Interactive comment on “Global root zone storage capacity from satellite-based evaporation” by L. Wang-Erlandsson et al.

L. Wang-Erlandsson et al.

Received and published: 22 February 2016

Fig. 1. Root mean square error improvements in STEAM evaporation simulation based on $S_{R,CRU}:E_{SM}$ when using various E data as benchmark reference.

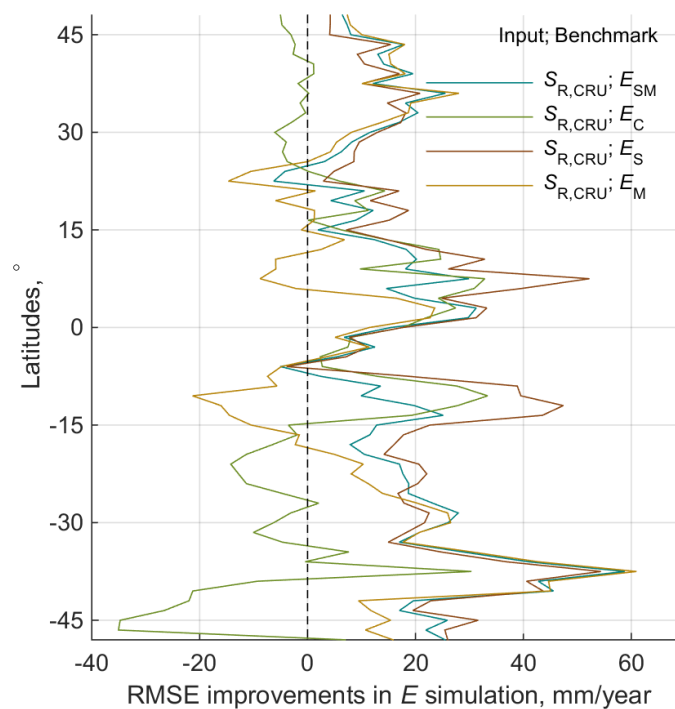
At Section 4.3 the authors assess the improvement of the new root zone storage capacity information within the STEAM model by comparing it to the same product with which the root zone storage capacity was developed. I wonder if this is an independent benchmark product or if you should use E_{CSM} instead (or only E_{C}) as benchmark. Sure, there is a lack of real observation based benchmark products for evaporation, but this is a weak point. You should select a different benchmark or rephrase the term benchmark.

We consider validation using E_{SM} to be appropriate, since the algorithms for estimating S_{R} , and for estimating E in STEAM are very different. First, S_{R} is derived based on the E overshoot over P , whereas STEAM is a process-based model where evaporation originates from five different compartments, each constrained by potential evaporation and related stress functions. This means that it is impossible to reproduce E_{SM} simply by inserting S_{R} to STEAM. If S_{R} is zero because E_{SM} never overshoots precipitation, STEAM soil evaporation and transpiration would become zero. If extreme S_{R} are produced because E_{SM} is unrealistically large, STEAM evaporation will not approach E_{SM} , since it will be capped by potential evaporation. Second, consider

also that the precipitation products (CRU and CHIRPS respectively) used for deriving S_R differ from the precipitation forcing (ERA-Interim) used in STEAM. Third, E_{SM} and STEAM are truly independent to each other as well. Whereas STEAM is process and water balance based, the ensemble E product is based on a combination of two(E_{SM})/three(E_{CSM}) well established energy balance methods. The only difference of the new STEAM simulations is the inclusion of updated information on root zone storage so that during longer periods of drought, more realistic estimations of continued evaporation processes can be expected. Last, $S_{R,CRU-SM}$ is based on a single year value of E_{SM} (i.e., the year of maximum storage deficit), whereas the analyses of improvements were based on the entire available time series of 10-11 years. Thus, the fact that $S_{R,CRU-SM}$ dimensioned on one year of E_{SM} nevertheless improves E simulation in STEAM with regard to 10-11 years of E_{SM} (i.e., the overall ϵ_{RMS} decreases when $S_{R,CRU-SM}$ is used in STEAM) is a strong indication that the storage capacity correction was implemented for the right reason. We maintain that the comparison with E_{SM} is useful and will clarify our arguments in the revised manuscript. Note also that STEAM is not calibrated by any means.

The referee suggests us to use E_{CSM} (or only CMRSET) as benchmark. Figure S4 (in the Supplementary Information) already shows the root mean square error (ϵ_{RMS}) improvements by latitudinal bands when using E_{CSM} as benchmark. Since E_{CSM} does not have global coverage, it was not possible to use it for the climate and land cover based analyses in Sect 4.3 and 4.4. In Figure 1 below, we also include ϵ_{RMS} improvements by latitudinal bands for the individual evaporation products CMRSET (E_C), SSEBop (E_S), and MODIS16 (E_M) when comparing monthly evaporation for the years 2003-2012. The use of more than one evaporation dataset decreases uncertainties related to individual evaporation products because there is simply not one single preferred model. Research executed by Hofste (2014) for the Nile basin demonstrated that the performance of an ensemble E product is significantly better than using individual E products, something that was confirmed by Simons et al. (in review) in Vietnam. Thus, we maintain that it is more useful to use an ensemble evaporation product as
